UNWANTED TRIPPING OF RESIDUAL CURRENT CIRCUIT BREAKER ON INDUCTION HOBS WITH TIGER POWER BOARD

DESCRIPTION:

Fig. 1

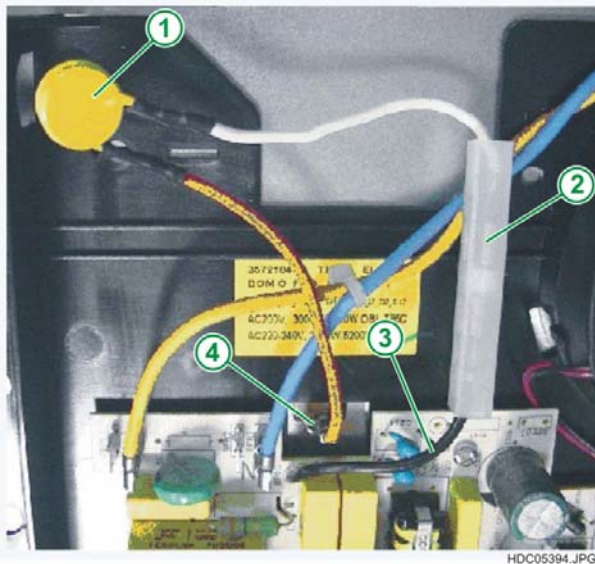
The modification is to insert a capacitor of 10nF (present in the kit) between the earth wire (see Point 3 on Fig. 1 and 2) and the earth connection of the frame (see Point 4 on Fig. 1 and 2) for each induction power board

- 1 - CAPACITOR 10nF (PRESENT IN THE KIT)
- 2 - LINE CONNECTOR (PRESENT IN THE KIT)
- 3 - EARTH WIRE (CONNECTED TO THE POINT 4 ORIGINALLY)
- 4 - CONNECTION OF THE FRAME EARTH
